STAFF RECOMMENDATION 1115 Greenwood Avenue April 19, 2017

Application: Setback determination
District: Eastwood Neighborhood Conservation Zoning Overlay
Council District: 06
Map and Parcel Number: 08301046400
Applicant: John Pirtle
Project Lead: Melissa Sajid, melissa.sajid@nashville.gov

Description of Project: Application is for right side setback determination to reduce the street-side setback from ten feet (10') to nine feet (9').

Figure 1: 1115 Greenwood Ave

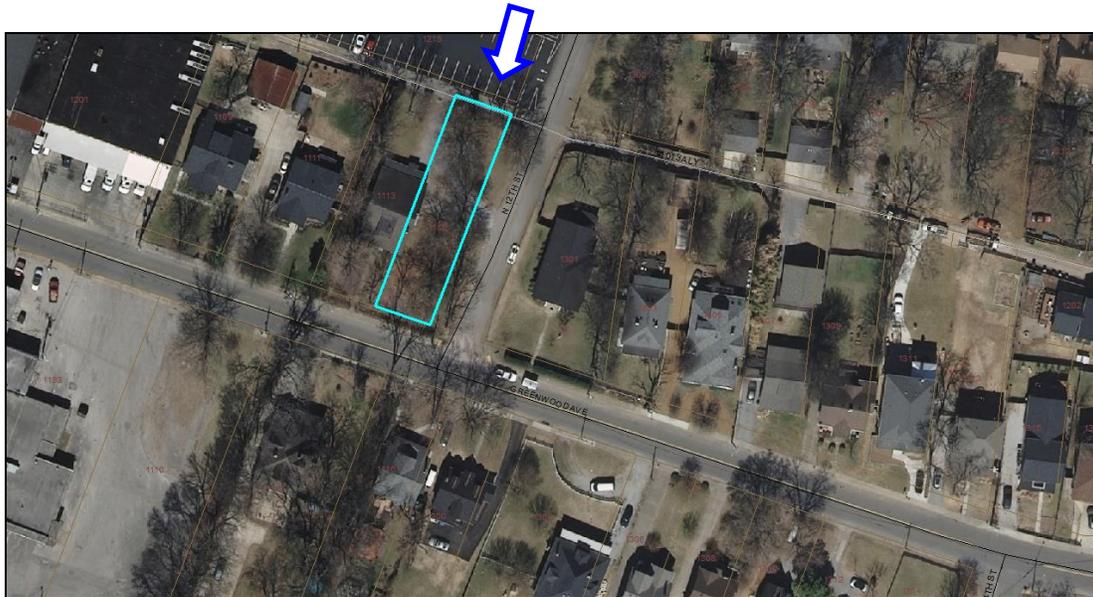
The lot is currently vacant and is located at the northwest corner of the intersection of North Twelfth Street and Greenwood Avenue (See Figure 1). The lot is approximately forty-six feet (46') wide at Greenwood Avenue, which is narrower than most lots in the immediate area. The setback determination is for the street setback along North Twelfth Street.

As the house is located on a corner lot, the minimum setback on the side street is ten feet (10'). The applicant has requested a right side setback determination to reduce the setback from ten feet (10') to nine feet (9'). Staff finds that reducing this side setback is appropriate. The lot is narrower than the typical lot in the immediate area, so reducing the right-side setback allows for a building footprint that is more appropriate for the context. In addition, there are other buildings along North Twelfth Street where the side of a building appears to be closer to the street-side property line than ten feet (10').

Staff finds that the setbacks to be appropriate and recommends approval of the setback determination. Staff finds that the project meets Section II.B.1.c.

FRONT ELEVATION

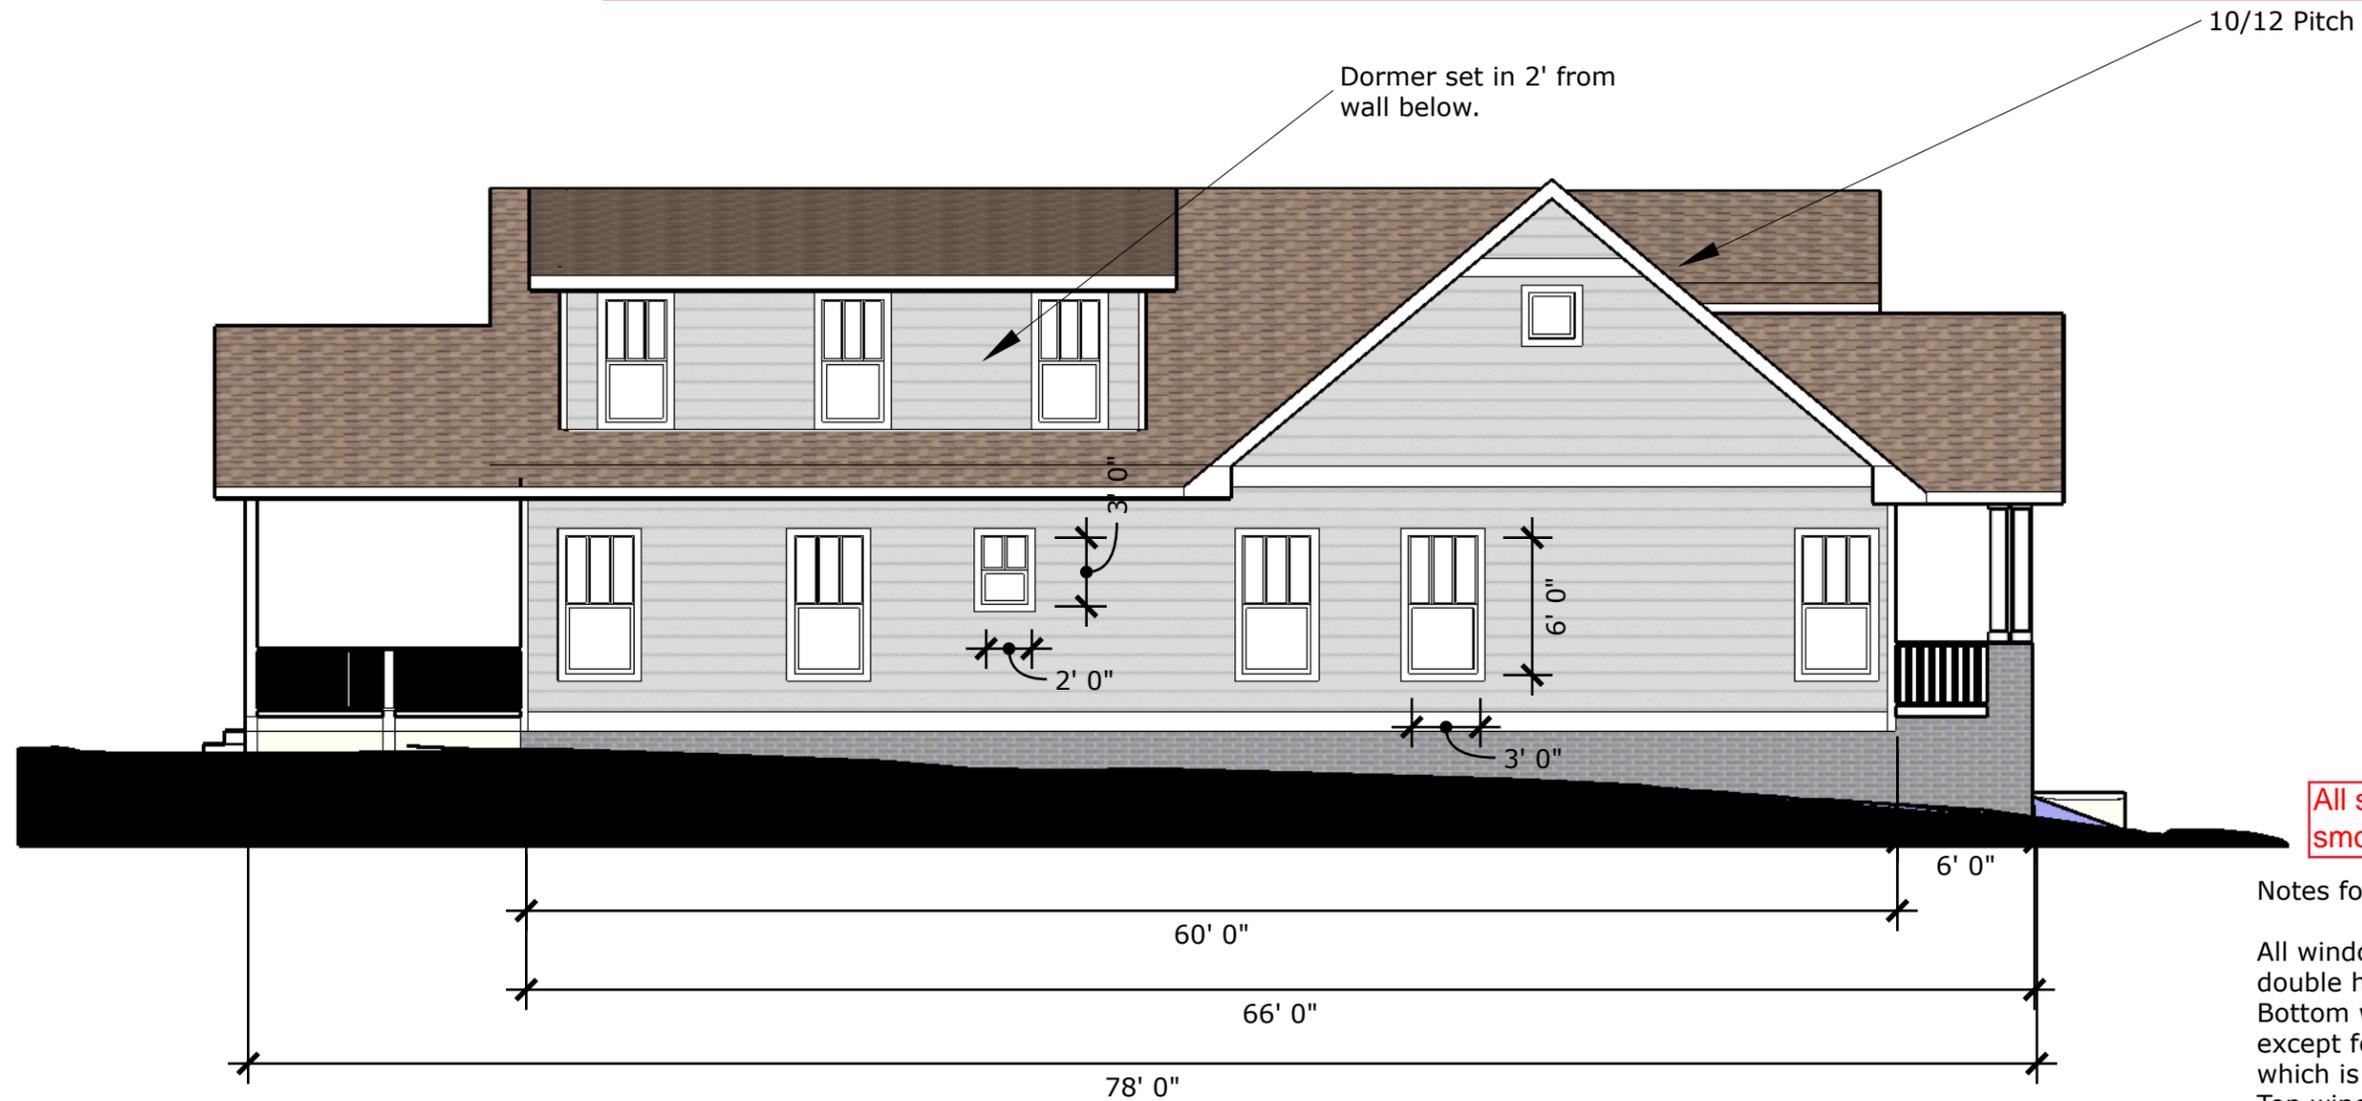
All siding shall be smooth-faced.

Scale 1/8" = 1' RIGHT ELEVATION

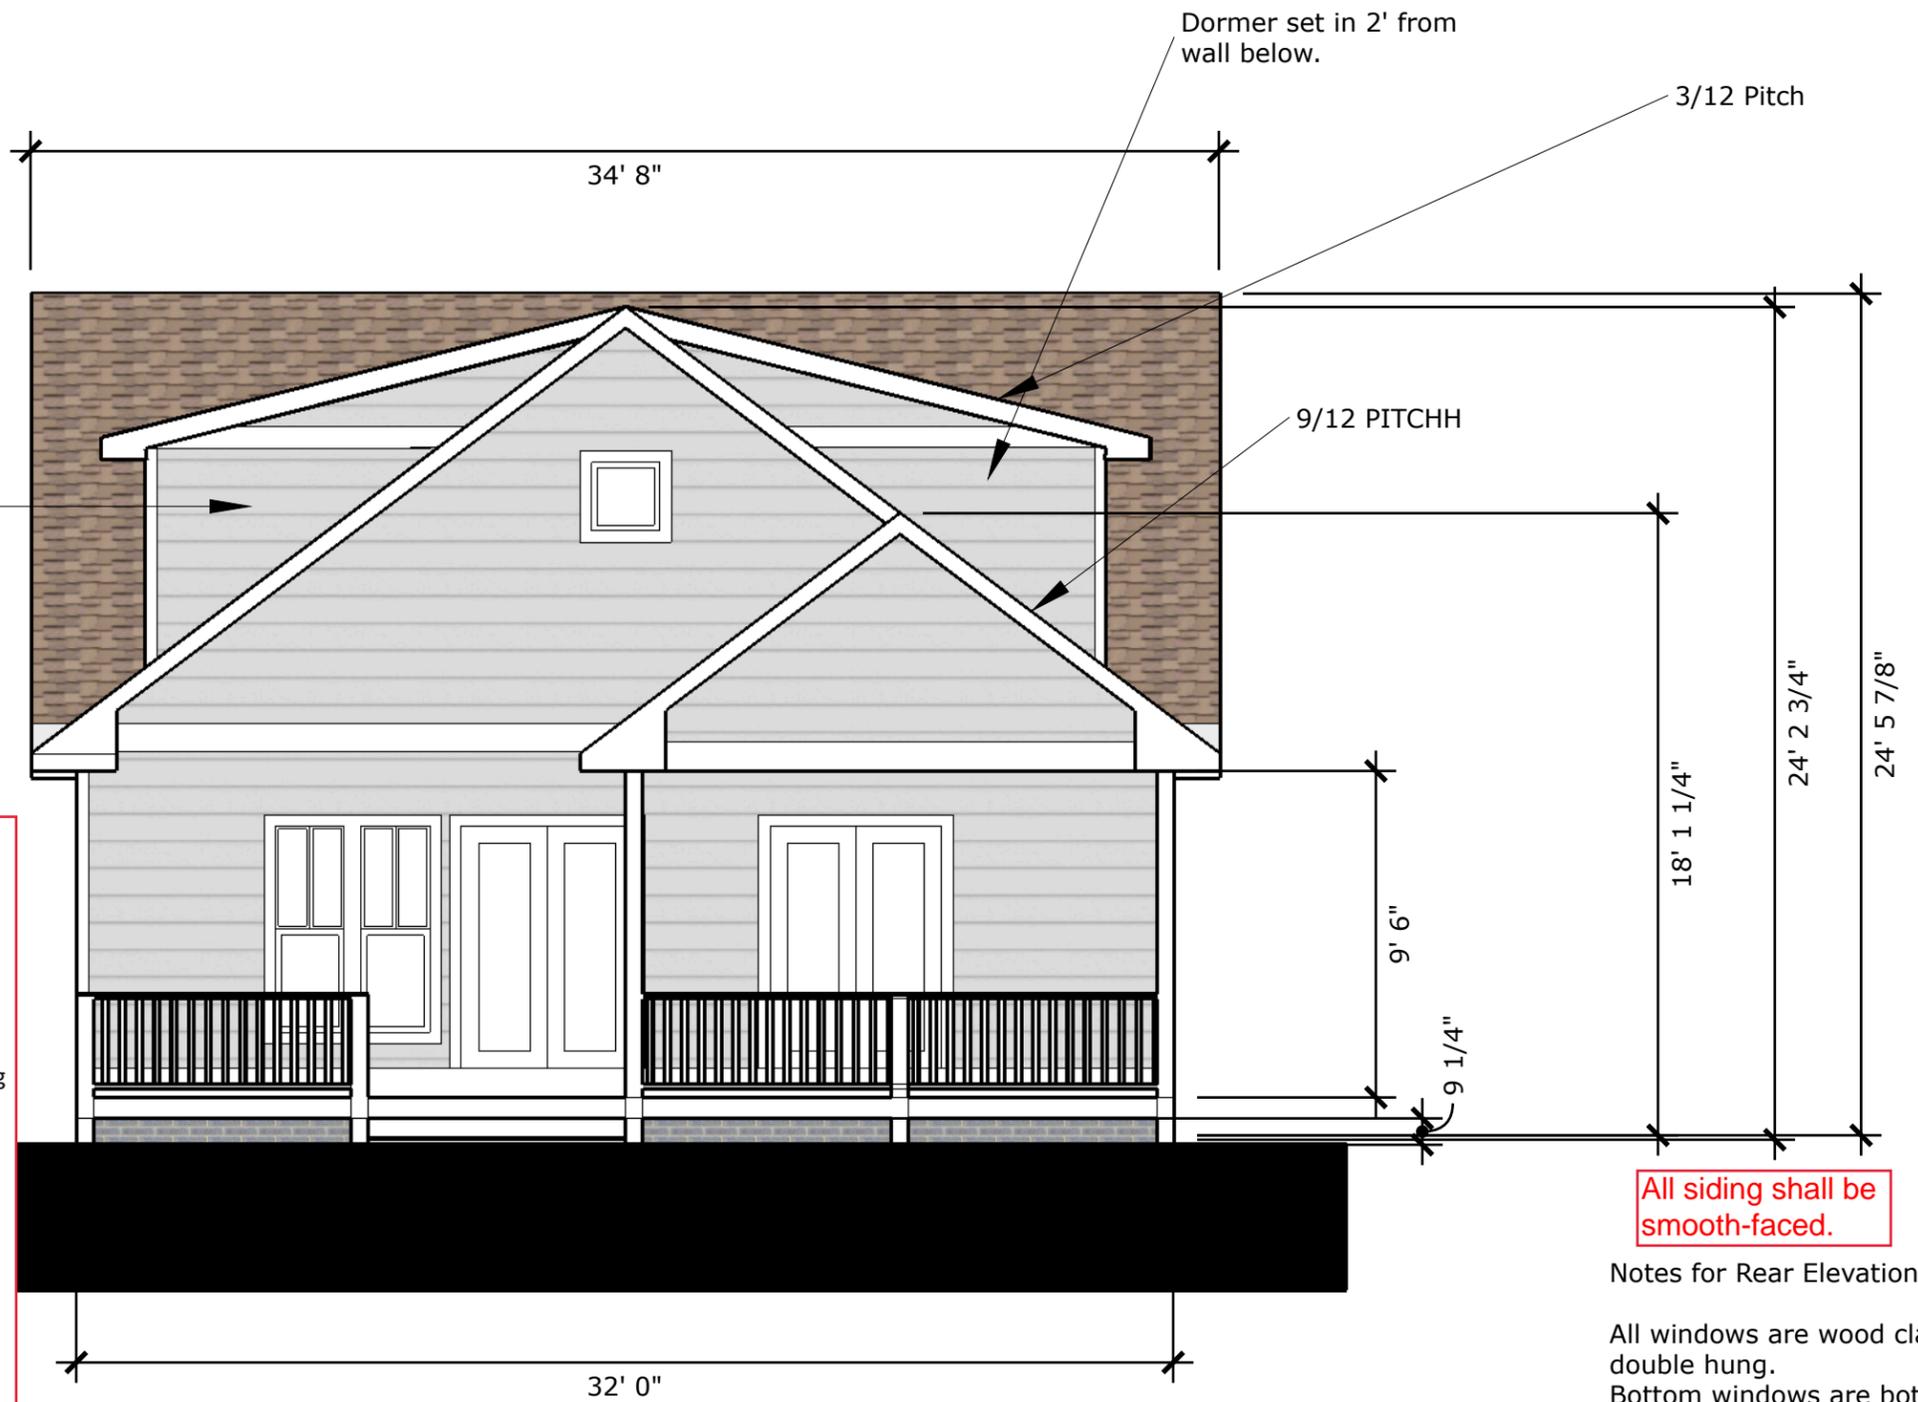
Dormer set in 2' from wall below.
